**Project Observation Minutes & Recommendations from Martin Aquatic
Holland Park IWF - Palm Coast**

Project:	Holland Park IWF		
Location:	Palm Coast, FL		
Report By:	Jonathan "JT" Toavs & Ken Martin		
Attendees:	JT, Ken, Mackenzie, and Drew from Martin Aquatic		
Issue Date:	2022.08.18	Revised Date:	
Subject:	IWF existing conditions Observation		
Weather:	Partly Cloudy

PlanGrid Task Report - Jul 23, 2022

2238 - Palm Coast Holland Park

#1 Finishes

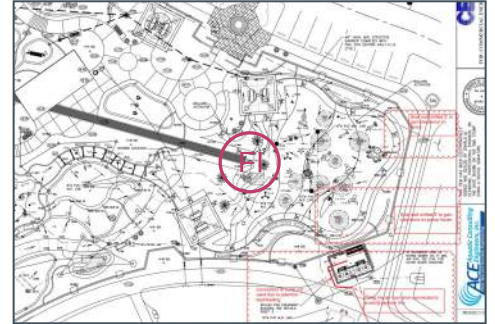
Overview of features - DRY and lack of decking adjacent features.

#2 Finishes

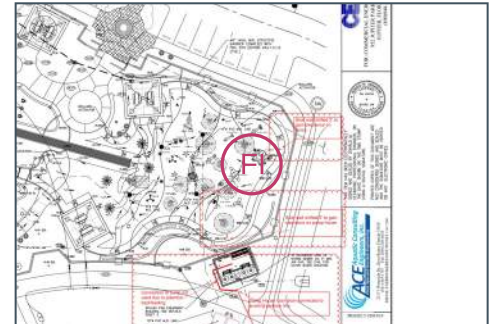
Areas of slope and drainage concern.

#3 Finishes

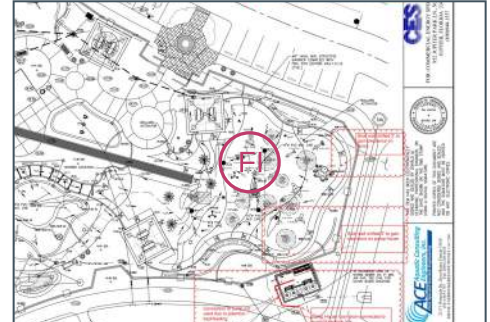
Description
Areas of slope and drainage concern.

#4 Finishes

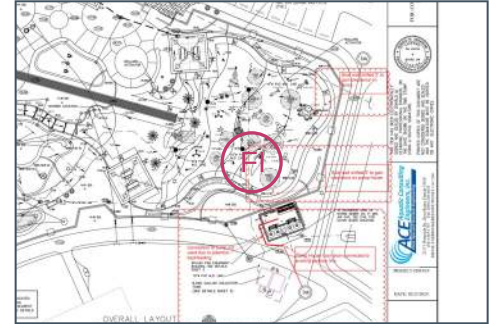
Areas of slope and drainage concern.

#5 Finishes

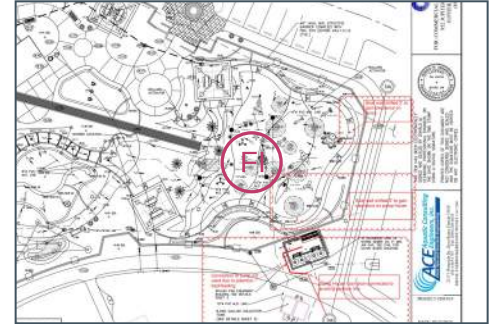
Areas of slope and drainage concern.

#6 Finishes

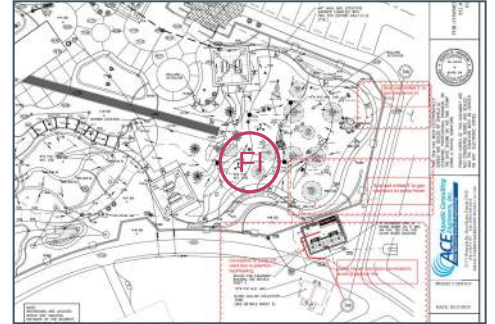
Surface failure and sample location.

#8 Finishes

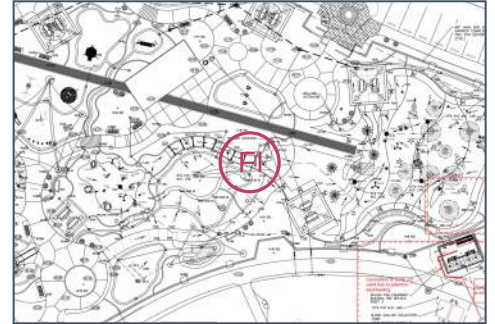
Multiple surface failures and lack of decking adjacent feature.

#10 Finishes

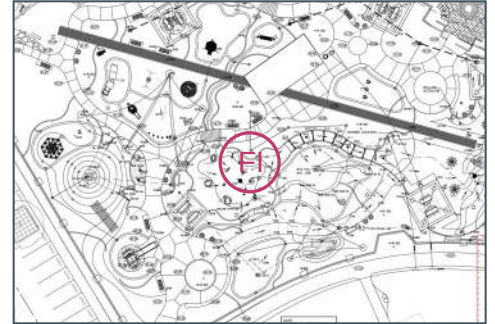
Area of slope and drainage concern and surface failures.

#28 Water

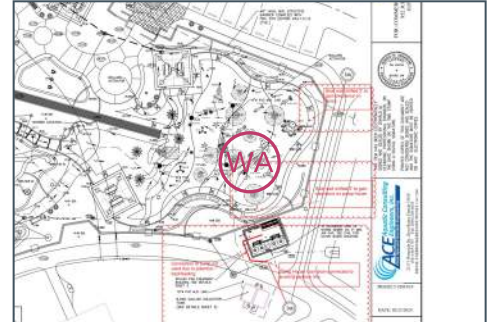
Area of slope and drainage concern and surface failures.

#29 Water

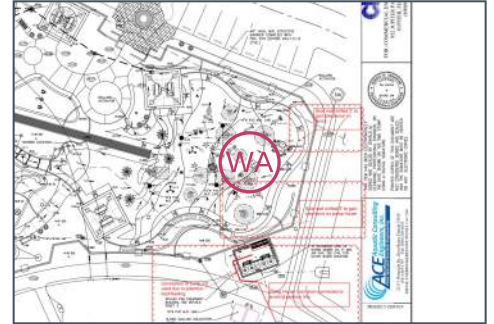
Area of slope and drainage concern and surface failures.

#33 Water

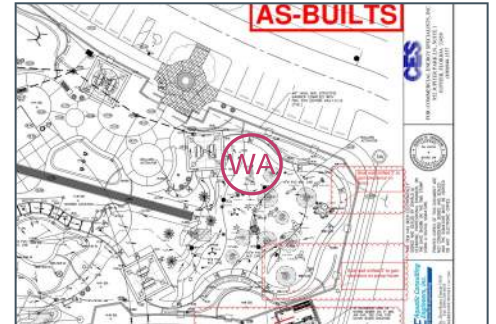
Area of slope and drainage concern and surface failures.

#36 General

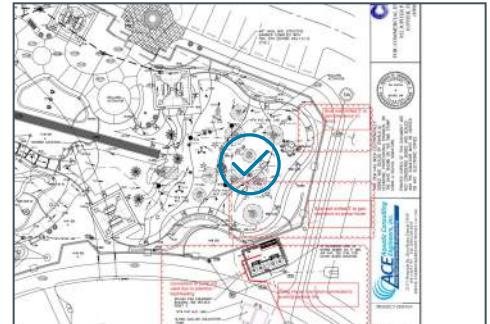
The slope for the record. The flat areas in the feature are capturing water. Insufficient slope per code.

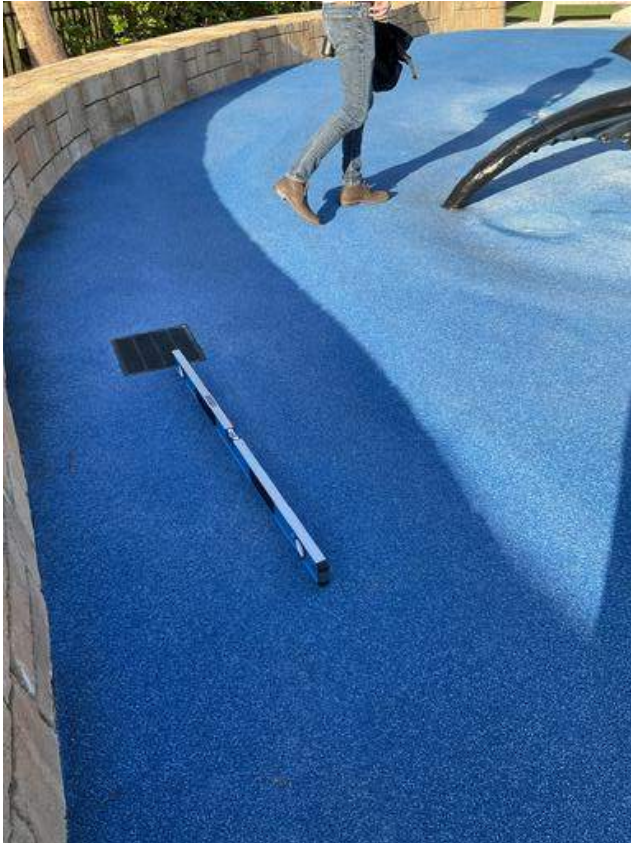
Perimeter decking is required to slope to drain at 2-4%. Slopes are inconsistent and the area does not slope away to drain. Insufficient slop to drain.
